Technical Service Bulletin

TBJ002D

Product: ATP32U01, ATP32U02 & ATA32U01 thermostats in conjunction with units using auxiliary electric heat.

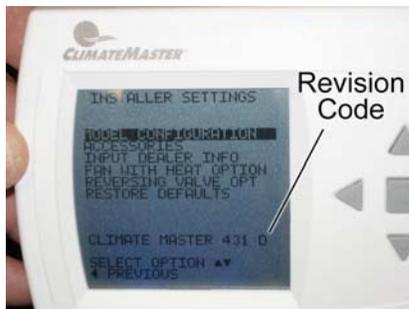
Issue: Auxiliary electric heat will not function unless used with the optional outdoor sensor (AST008). During temperatures that require auxiliary electric heat, thermostat set point will not be achieved. The emergency electric heat mode does function properly as does electric heat during a “lock out” mode.

Effected Range: Uninstalled thermostats can be checked by the date code and/or part number. The thermostat’s box label (shown lower right) lists the part number and date code (first 2 digits indicate week, last 2 digits indicate year). Return any thermostat with date code of **3506** or before without the part number highlighted in yellow. Correctly programmed thermostats have either a date code of **3606** or later or any date code with the part number highlighted in yellow. Example would be of lower right picture; even though date code is before 3506, the part number is highlighted in yellow indicating this thermostat has the correct program. Installed thermostats should be checked by the revision codes (shown in lower left picture). Compare revision codes to the chart listed below.

Solution: Effected thermostats must be replaced and returned to ClimateMaster. Replacement thermostats must be ordered through the Business Center, credit will be issued upon receipt of returned thermostats to ClimateMaster. Request a Return Authorization in the comment section of the order.
